Technical Service Bulletin

01 MIL on, (DTCs P047F, P0477, P048A, P048B, P048C, P0401)

01 13 77 2033356/1 March 15, 2013.

| Model(s) | Year | VIN Range | Vehicle-Specific Equipment |
|----------|-----------|-----------|----------------------------|
| A3 TDI | 2010-2012 | All | Exhaust flap |

Figure 1. Exhaust flap

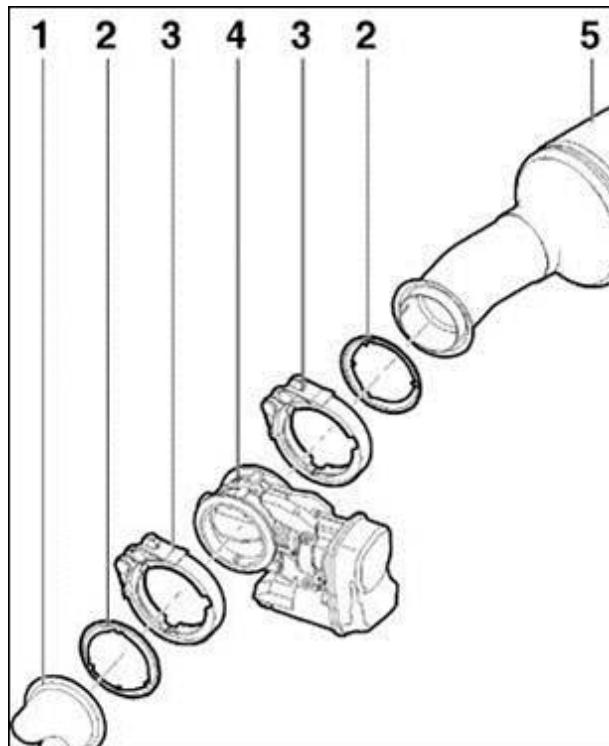
Water and road salt can corrode the exhaust flap shaft causing it to stick in open / closed position.

1. If one or more of the above faults are stored in the ECM fault memory, remove the exhaust flap to check for a sticking condition (Figure 1, 4)

2. If the flap cannot be moved or does not move freely, the flap must be replaced.
